AMENDMENT OF SOLICITATION/MODIFICATION OF CONTRACT			1. CONTRACT ID CODE	PAGE OF PAGES	
			J	1	2
2. AMENDMENT/MODIFICATION NO. 0001	3. EFFECTIVE DATE 02-Jul-2004	4. REQUISITION/PURCHASE REQ. NO. W38XGR-4104-9035		5. PROJECT NO.(If applicable) W912EQ-04-B-0021

14. DESCRIPTION OF AMENDMENT/MODIFICATION (Organized by UCF section headings, including solicitation/contract subject matter where feasible.) This solicitation for Wolf River Item 1 Channel Stabilization Weirs and Earthen Berms scheduled to open 15 July 2004 at 2:40 PM is amended in accordance with the attached Summary of Changes:					
Except as provided herein, all terms and conditions of the document referenced in Item 9A or 10A, as heretofore changed, remains unchanged and in full force and effect.					
15A. NAME AND TITLE OF SIGNER (Type or print)			16A. NAME AND TITLE OF CONTRACTING OFFICER (Type or print)		
			TEL: _____ EMAIL: _____		
15B. CONTRACTOR/OFFEROR _____ (Signature of person authorized to sign)	15C. DATE SIGNED	16B. UNITED STATES OF AMERICA BY _____ (Signature of Contracting Officer)		16C. DATE SIGNED 02-Jul-2004

WOLF RIVER, ITEM 1
 CHANNEL STABILIZATION
 WEIRS AND EARTHEN BERMS
 SHELBY COUNTY, TENNESSEE

"R-200"

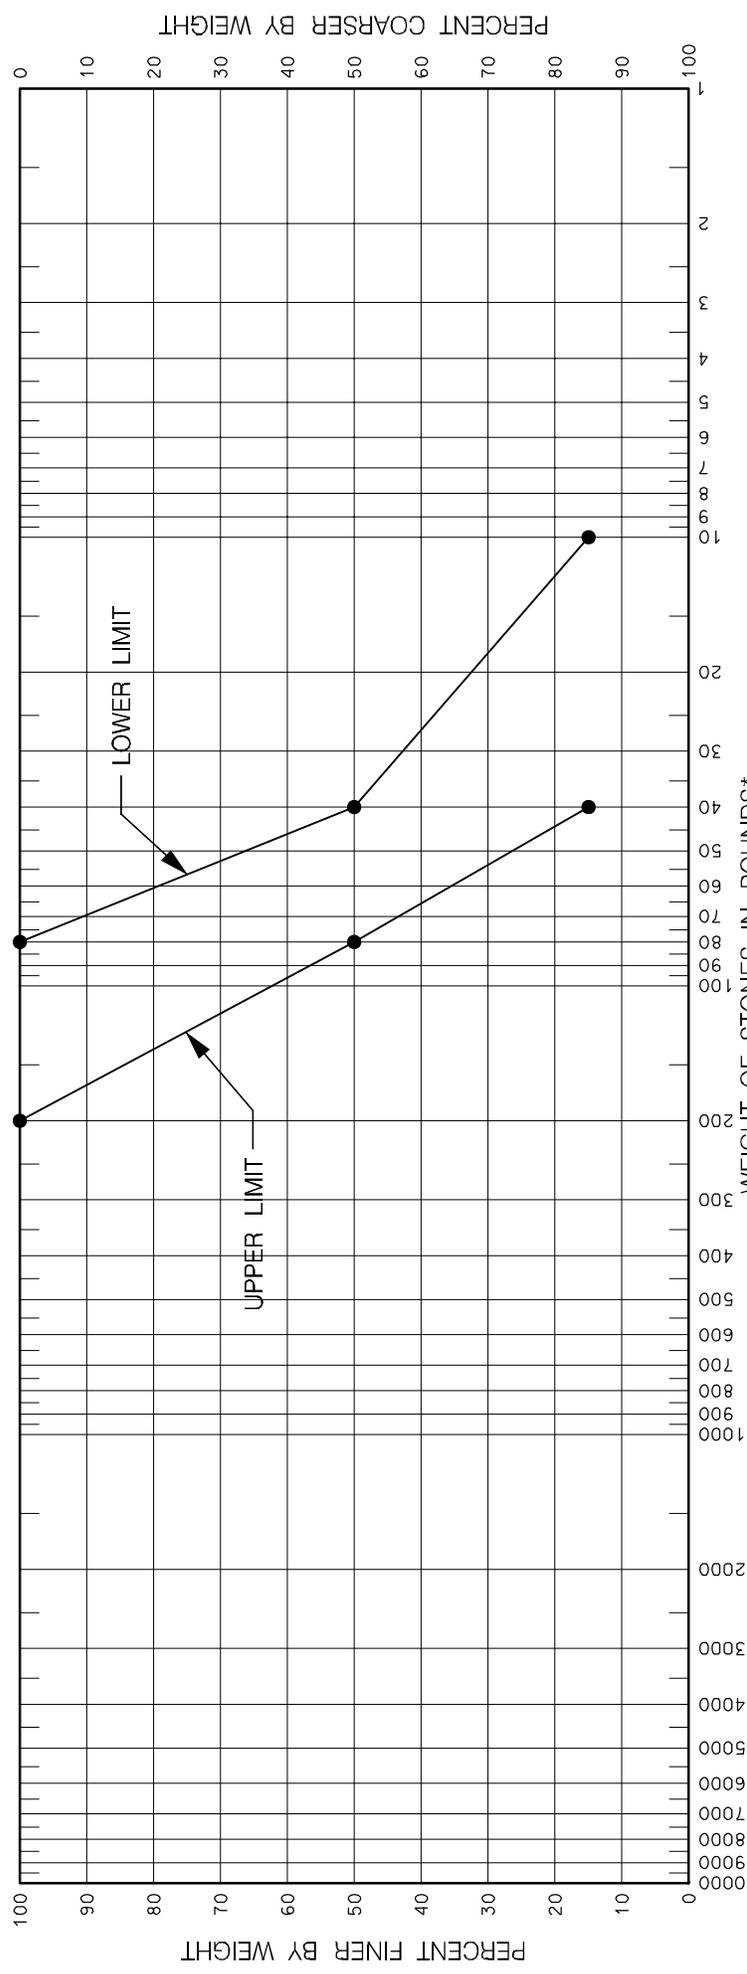
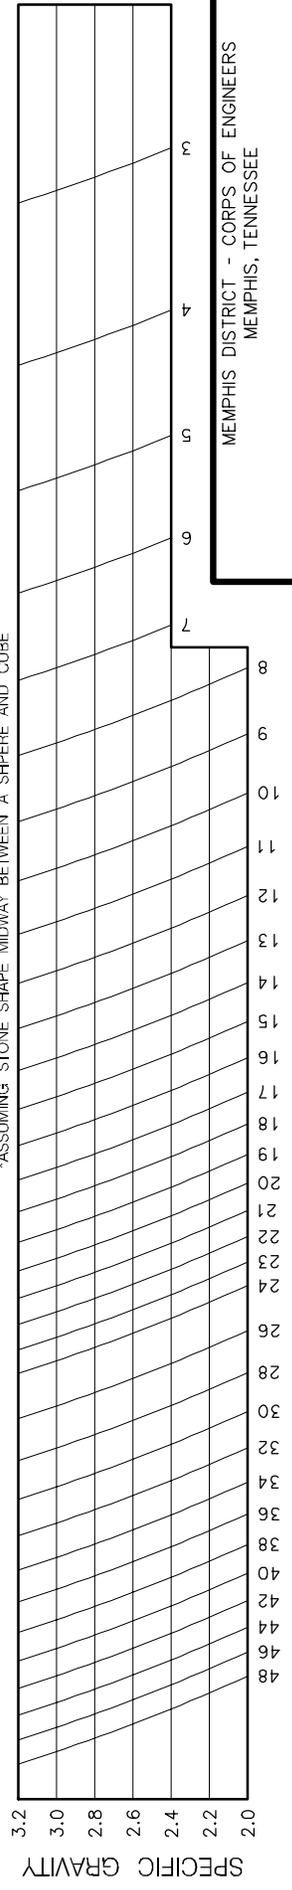
9. SECTION 02542. Add the attached Blank Gradation Sheets for R200 and R2200rev.
